# RX65N Group

Cloud Kit for RX65N Microcontroller Group  
CK-RX65N v2  
Errata

CK-RX65N v2 – Errata

Figure 1. USB C to Serial Interface Schematic

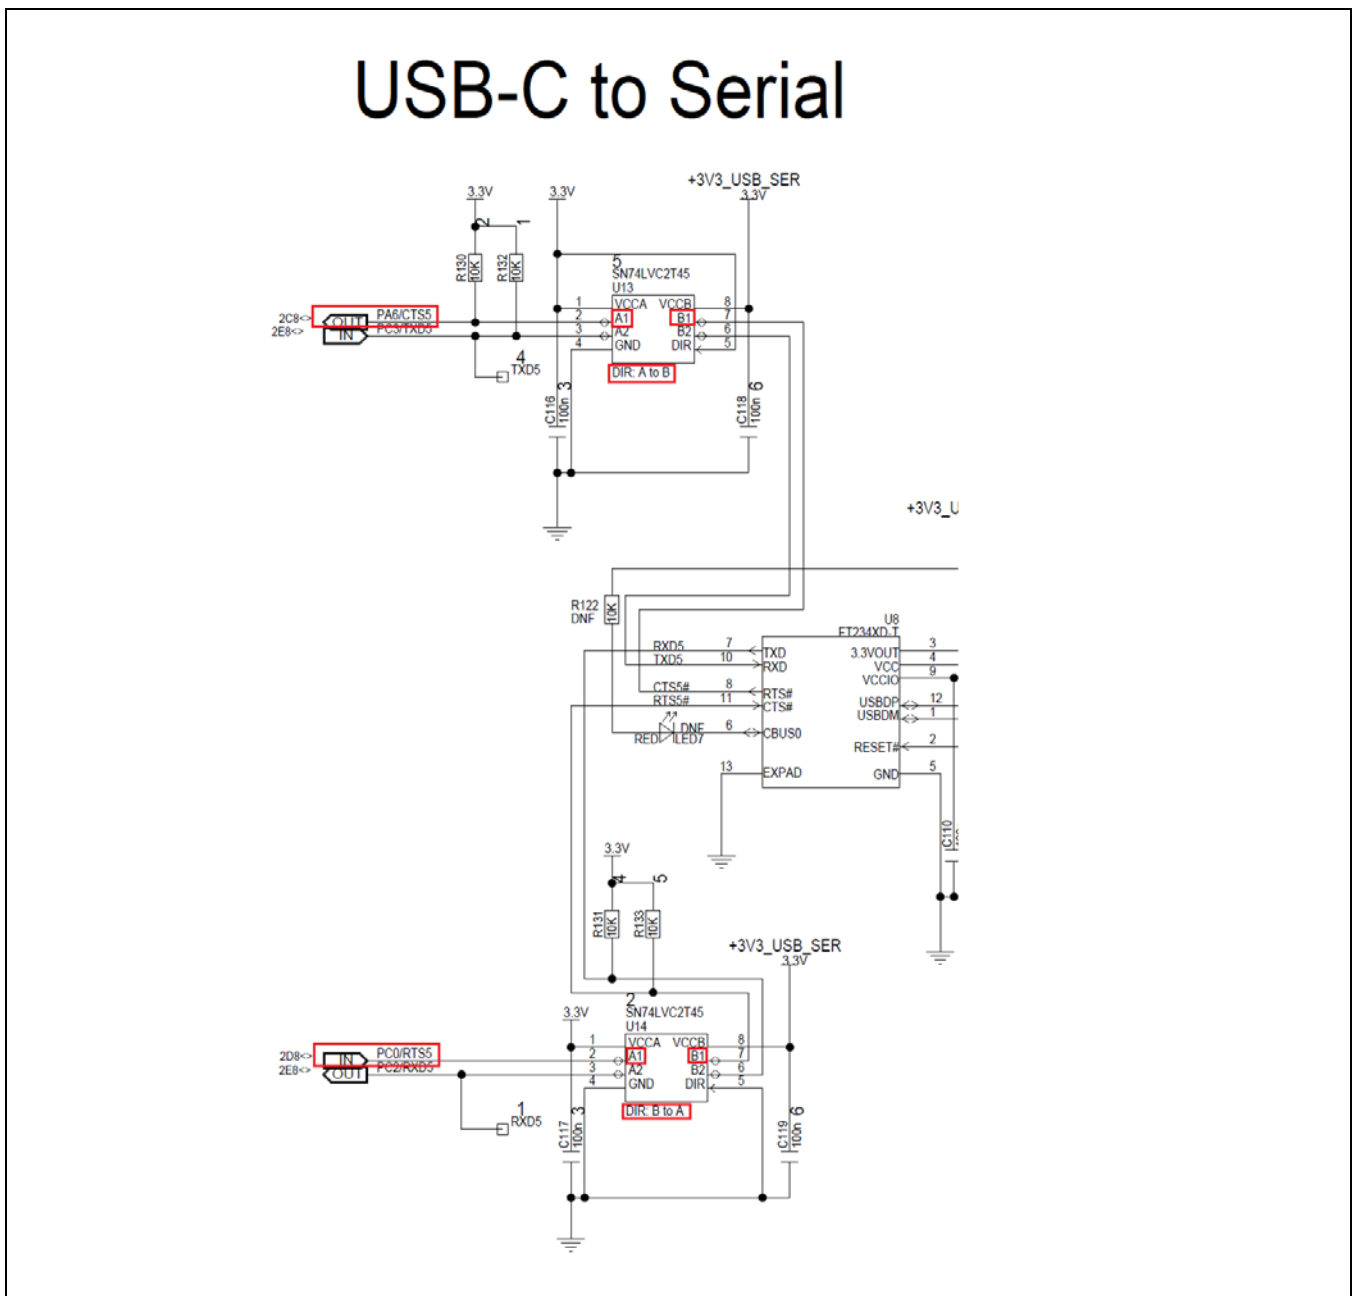
In the USB-C to Serial interface, pins 2 and 7 of devices U13 and U14 are incorrectly connected and should have their connections reversed. Specifically, the CTS# and RTS# signals are swapped relative to the FTDI device’s expected pin orientation.

As a result of this misconnection, the polarity of the hardware flow-control signals is inverted, and hardware flow control becomes non-functional.

To avoid electronic conflict, **manually configure pin PC0 as a GPIO input.**

There is no corrective action. Hardware flow control cannot be used.

This issue will be corrected in later versions of the kit.
